*BEACON PLANNING BOARD*  
*One Municipal Plaza - Courtroom*  
*BEACON, NEW YORK 12508*  
*Phone (845) 838-5002 Fax (845) 838-5026*

The Planning Board will meet on **Wednesday, February 13, 2019** in the Municipal Center Courtroom. A work session will take place at 7:00 PM for a training workshop, discussion of agenda items and/or topics of interest to the Planning Board. The regular meeting will begin immediately thereafter, but not later than 7:30 p.m.

**Re: 511 Fishkill Avenue Street, Beacon, New York**  
*Site Plan Application – Responses to Comments*

Re: Site Plan  
511 Fishkill Avenue (NYS Route 52)  
Tax parcel: 6055-04-580285 ( $\pm$ 10.33 acres)  
City of Beacon, NY

**SITE PLAN**  
SCALE: 1" = 20'

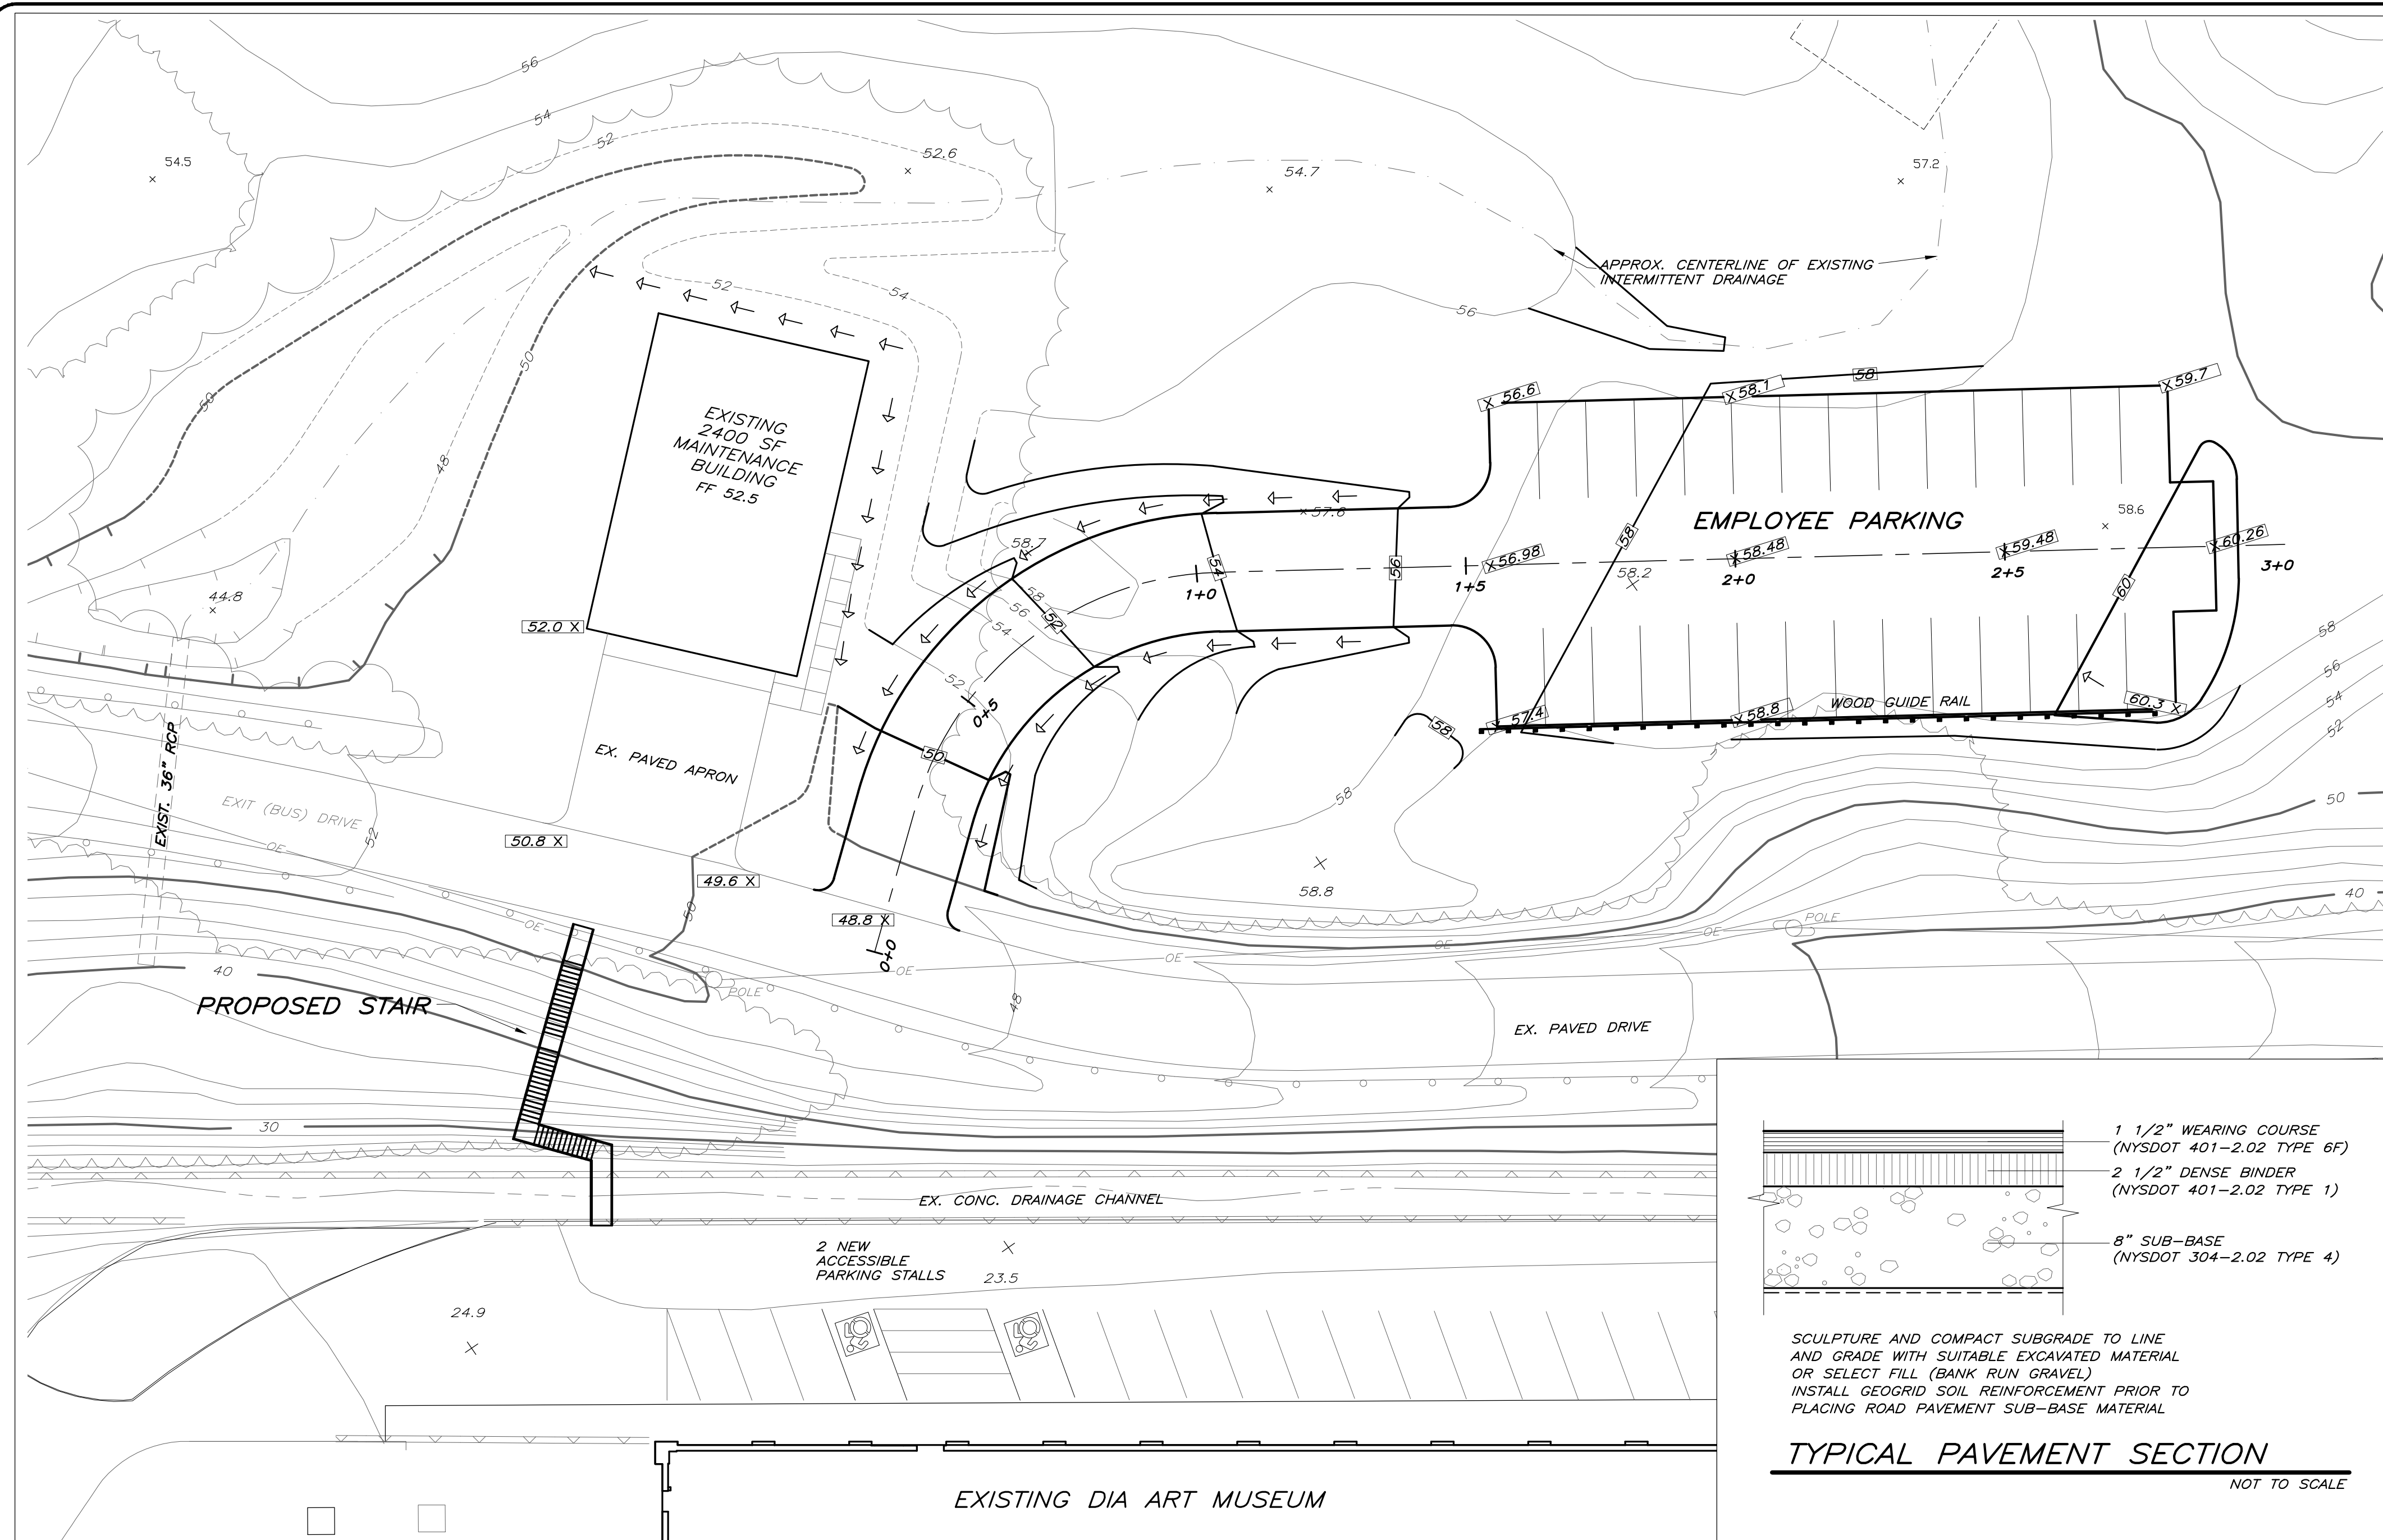
1. The submitted Short EAF shall be dated and signed.
2. As shown on Sheet 2, the drainage on the north side of the parking lot entrance is shown to be draining towards the secondary access road, we would recommend that a drainage pipe be installed under the parking lot access drive to convey run-off to the drainage swale located on the south side of the parking lot entrance so that it does not flow out and across the secondary access drive.
3. The proposed stairway is shown to crossover the existing concrete drainage channel. The “Pedestrian Stair Elevation” on Sheet 2 notes that this crossing is to be accomplished by means of a footbridge. Construction details for this foot bridge should be provided on the plans.

7. Construction details for the proposed accessible parking stalls should be provided on the plan along with the required signage. The Site Plan on Sheet 2 should show the location of the required signage for these parking stalls and access aisle.

1. The Site Plan detail on Sheet SP2 should show the species and diameter of all existing trees over six inches in diameter within the area of disturbance and indicate any major trees that will be removed.

**SP3**  
OF 4

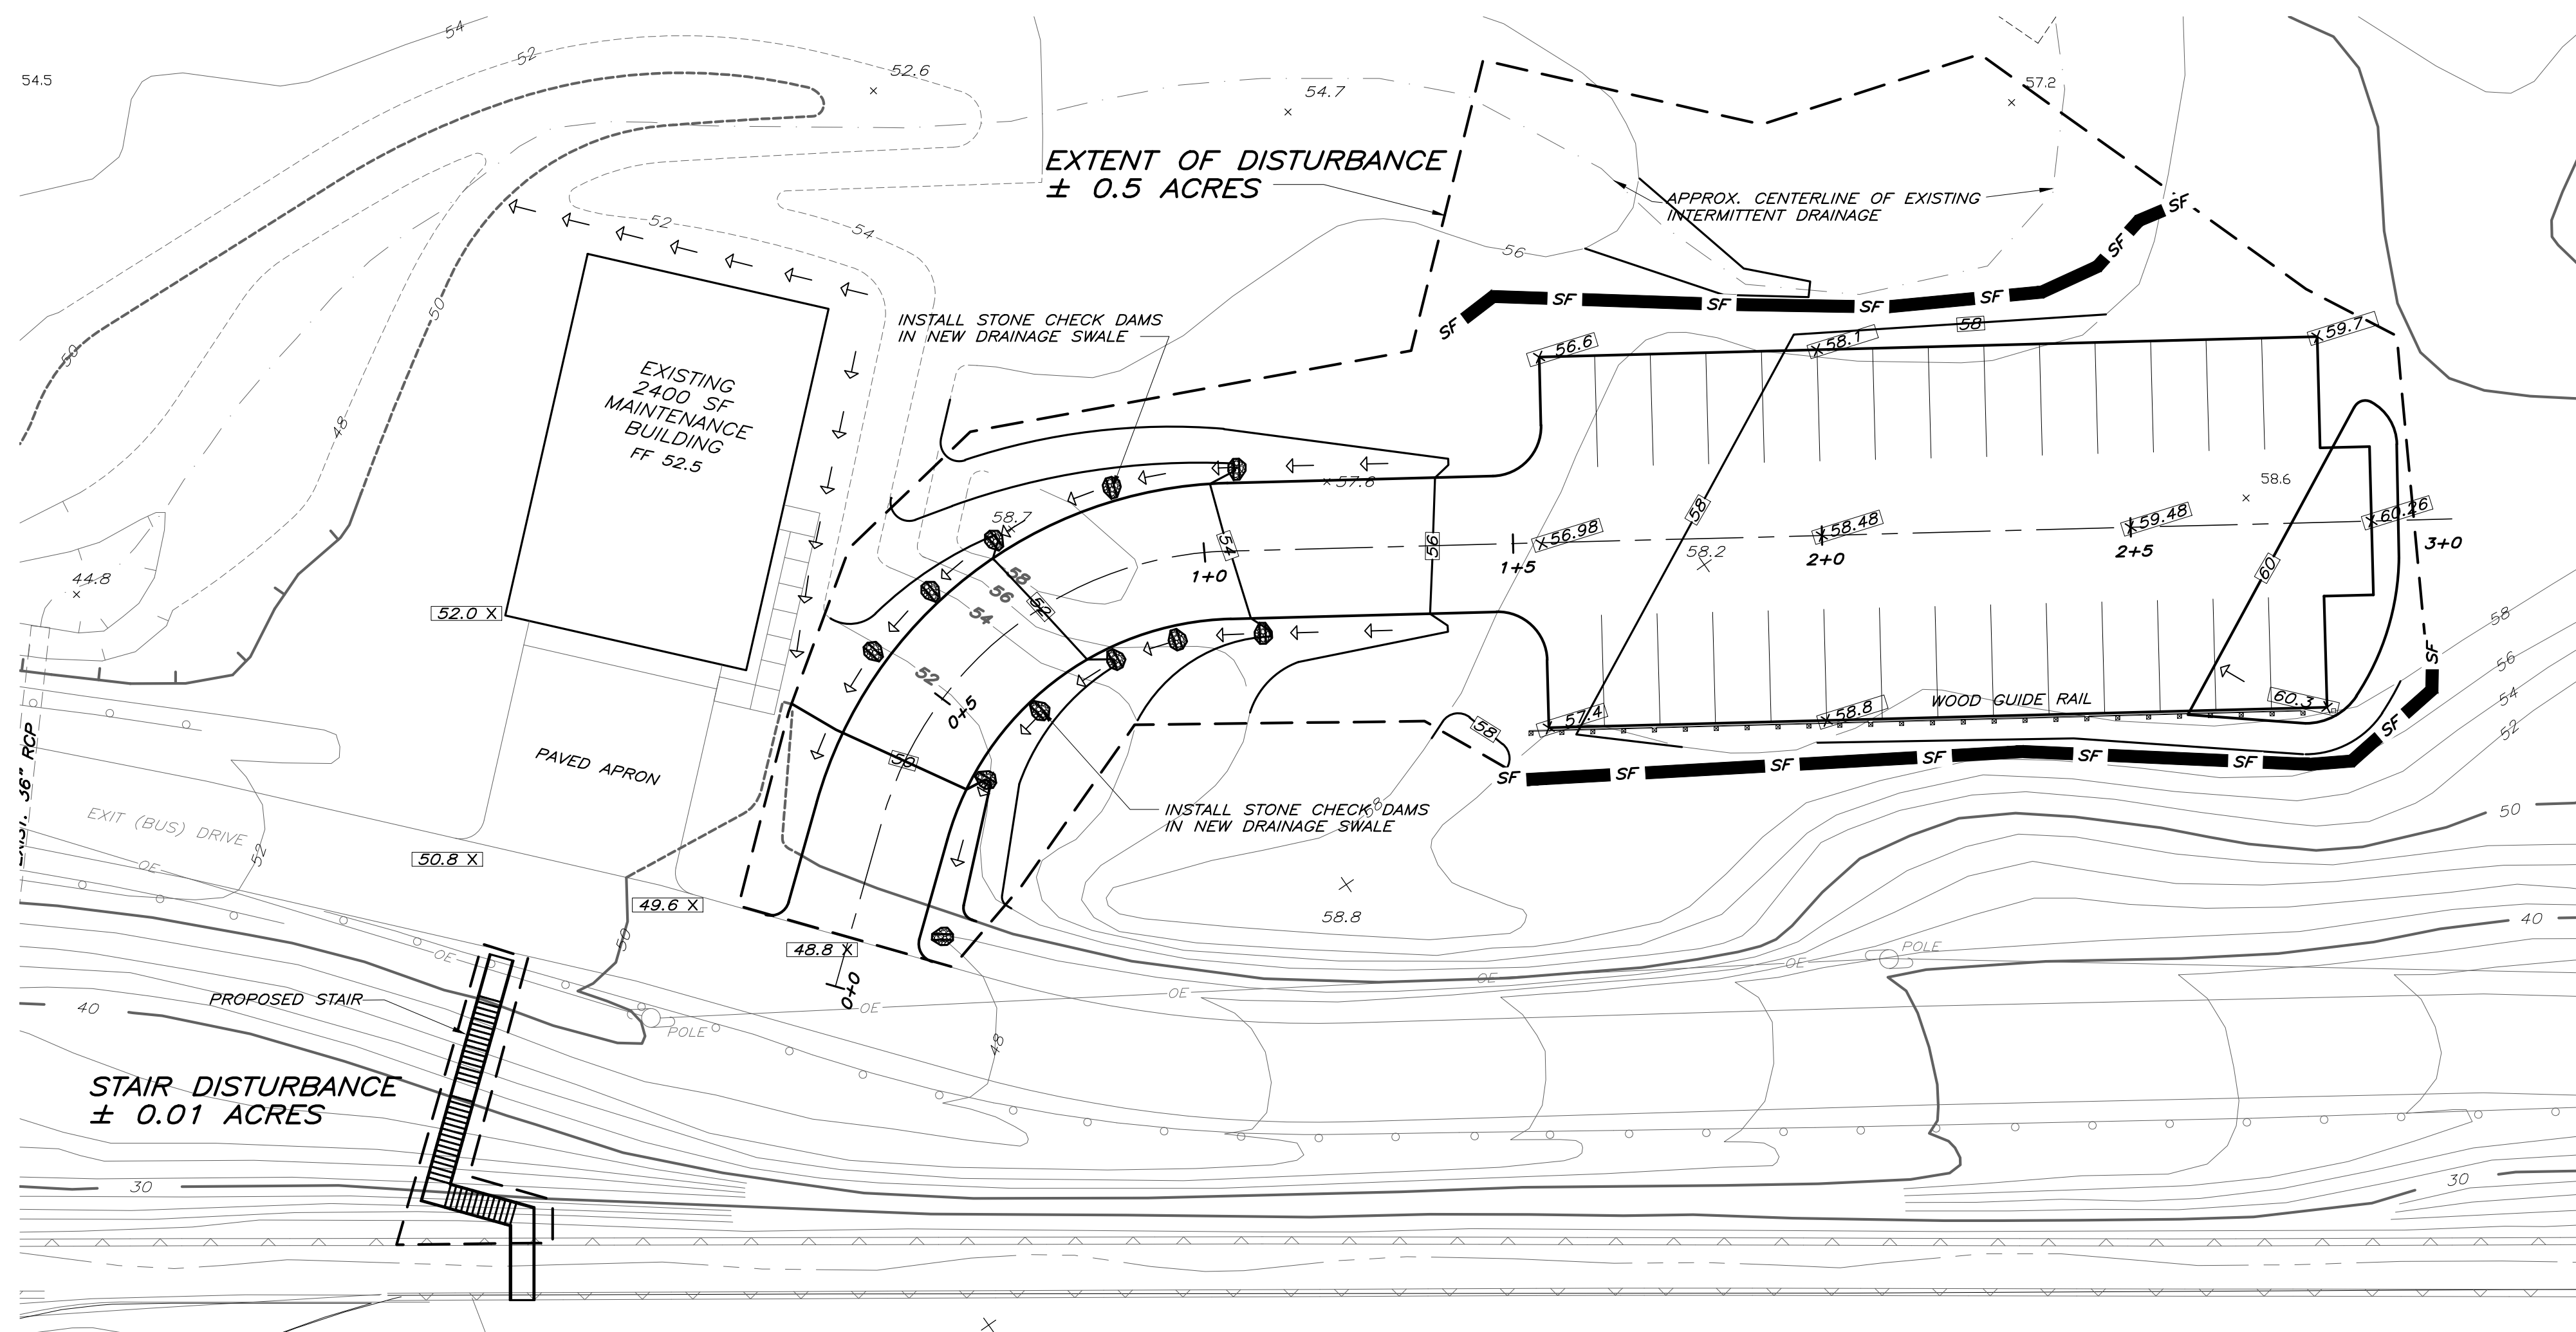
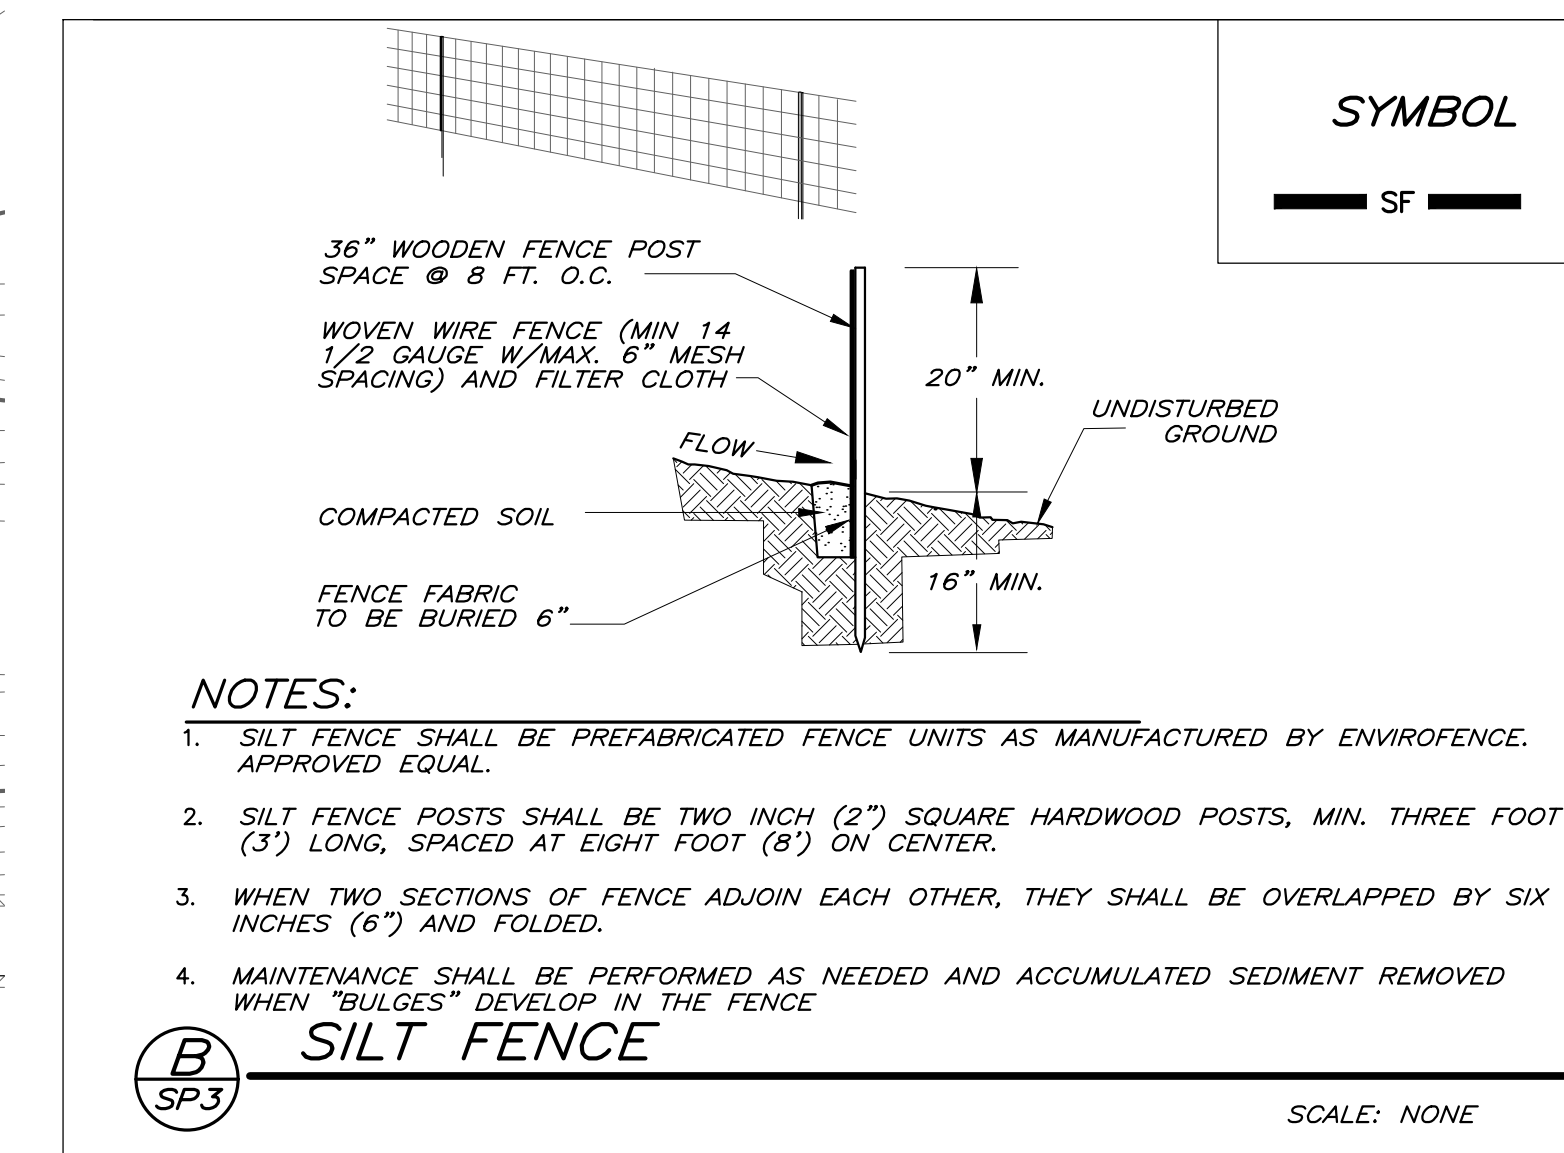
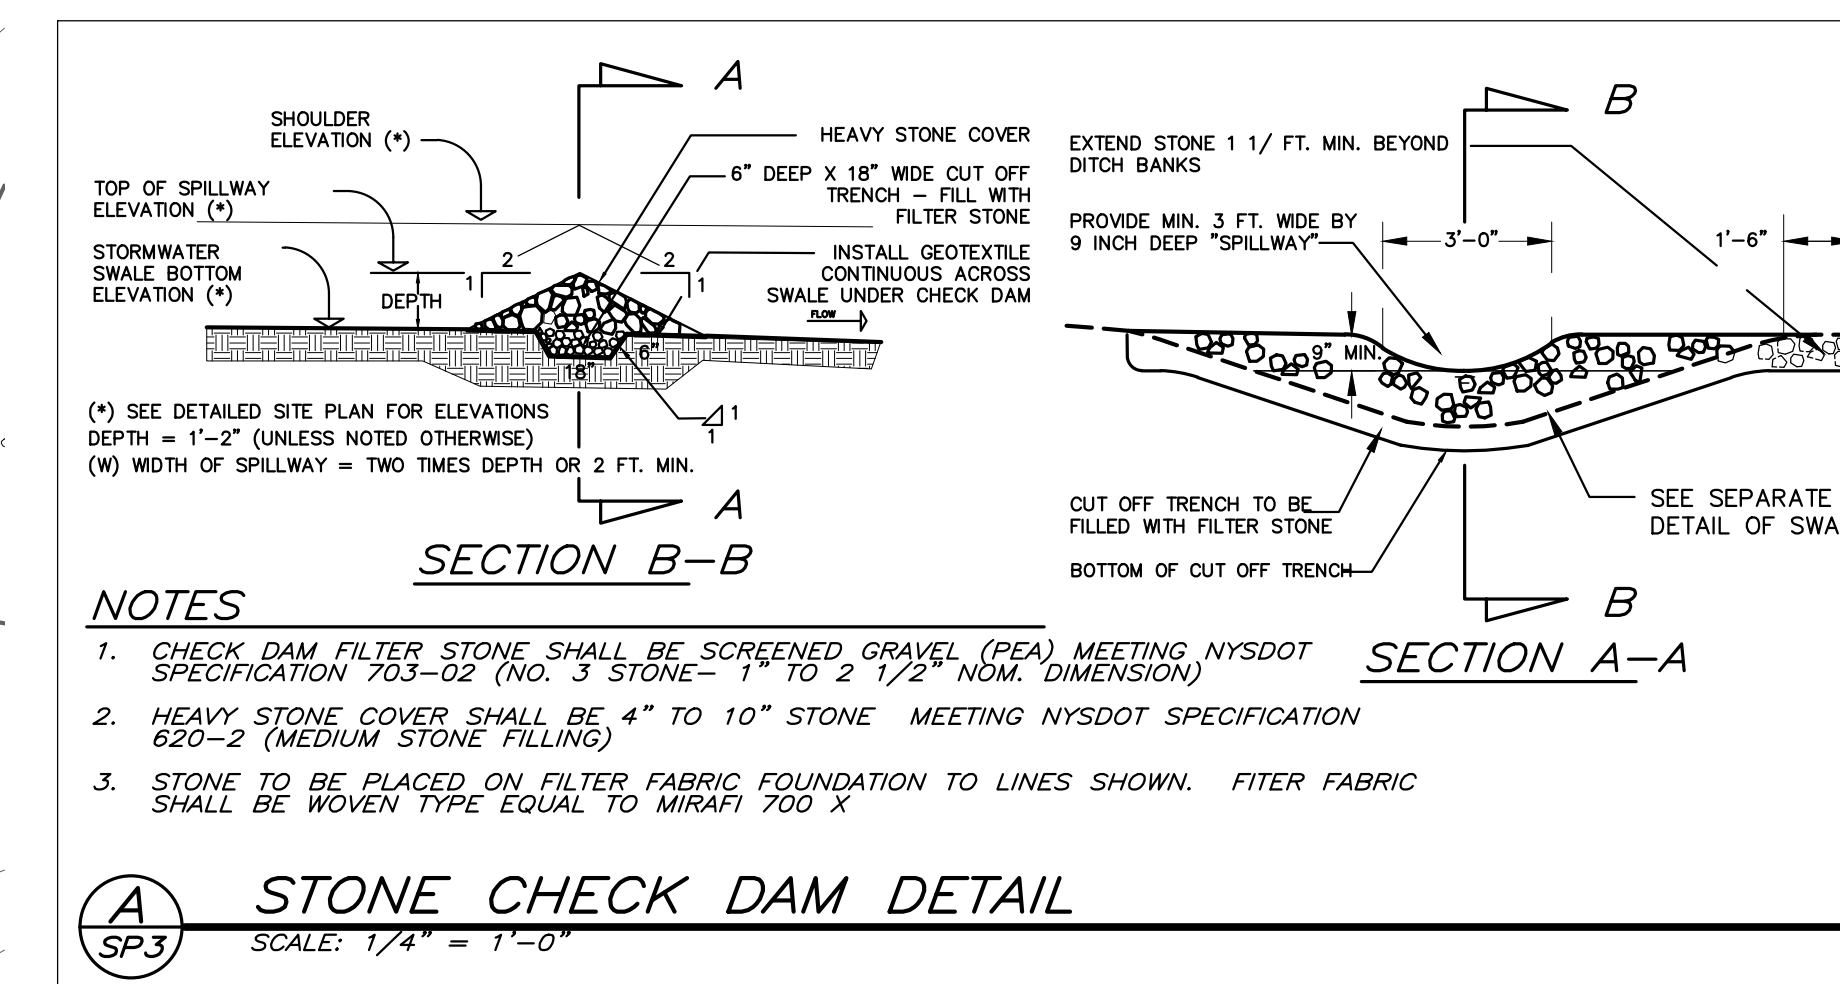
4. Sheet 3 shows the proposed bollard lights along the parking lot entrance drive located in the drainage swale. We would that these lights be removed from the drainage channel by either shifting the lights further back or shifting the drainage channel back.

5. The lighting details on Sheet SP3 should include a note that the fixtures will be dark sky compliant and will prevent the source of light from being seen from any adjacent residential property.
